LIPPERT
COMPONENTS®

Product Improvement Notice - New bracket for bike racks

From left are current bike rack brackets 243632 and 369559 and new bracket 719822.

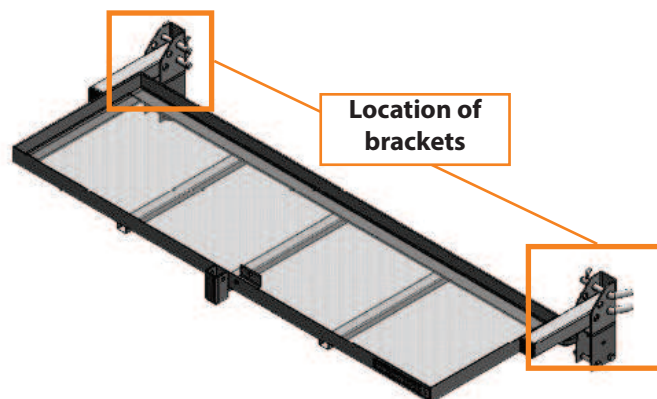
Bracket 719822 will replace brackets 369559 and 243632, which will become obsolete.

- 719822 (new) – Is now a three-piece weldment made with all plates
- 369559 (old) – Is a two-piece weldment made with formed parts (hereinafter XMCs)
- 243632 (old) – Is a two-piece weldment made with XMCs

The new bracket was designed for more efficient and accurate production. The three plates are set in a fixture, making the product more consistent than the welded XMCs.

There is no change in the way the brackets install and no change in fit, form or function with the product improvement. There is also no price change. The change will be made on a running basis, starting around Sept. 14.
